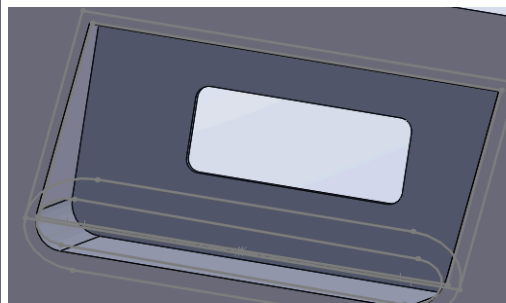
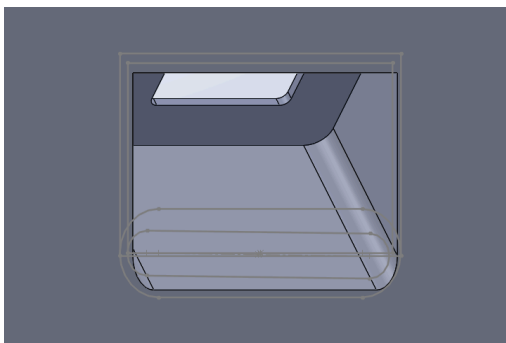
1. Need to add an extended part to the ultrasonic sensor holes in order to control its sound beam. A sample SolidWorks file is attached below to provide an idea of its structure, **but we need to figure out how to mount it to the previous structure**. The dimensions of the clip are the same as those provided in the SolidWorks design.

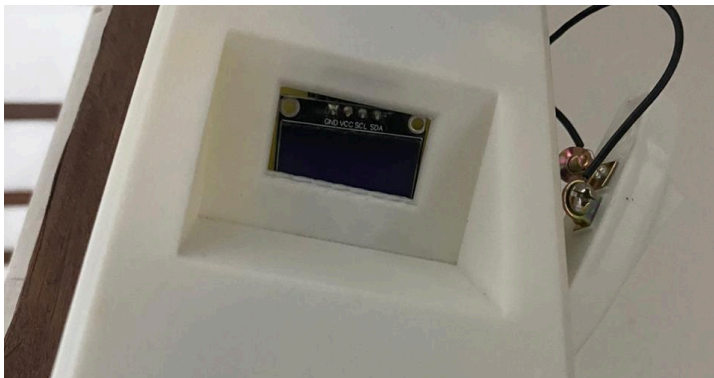
2. Need to modify the vertices and some edges of the display hole. Here is how it should be adjusted.
